66321B-09

S E R V I C E N O T E

66321B – Mobile Communication DC Source, 15V/3A with Battery Emulation. GPIB

Power-On Self test Errors, Auto reboot, Blank display. No output Communication errors. No communication when using the GPIB Interface.

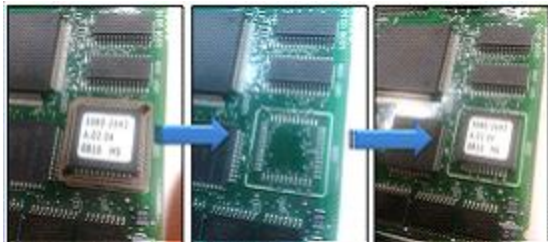
When the EEPROM is installed in the PLCC SOCKET (**Circuit Reference U205**) on the Interface board if there is not a gas tight connection between the EEPROM pins and the socket pins an intermittent connection will occur.

It has been determined when removing the socket and soldering the EEPROM (circuit reference U205) directly on the interface assembly “A2” would be very difficult (See Picture below), even having the correct tools, removal of the socket and replacement of the EEPROM is very difficult and may cause additional quality and reliability issues.

1. The problem can be solved by replacing the GPIB Interface assembly. See above for the tested interface P/N that is required to repair the instrument. The correct tested assembly for the specific model must be used when repairing a defective instrument.
2. This problem can also be solved by removing the socket (circuit reference U205) on the “A2” interface assembly and soldering the **Original** EEPROM directly to the Printed Circuit assembly.
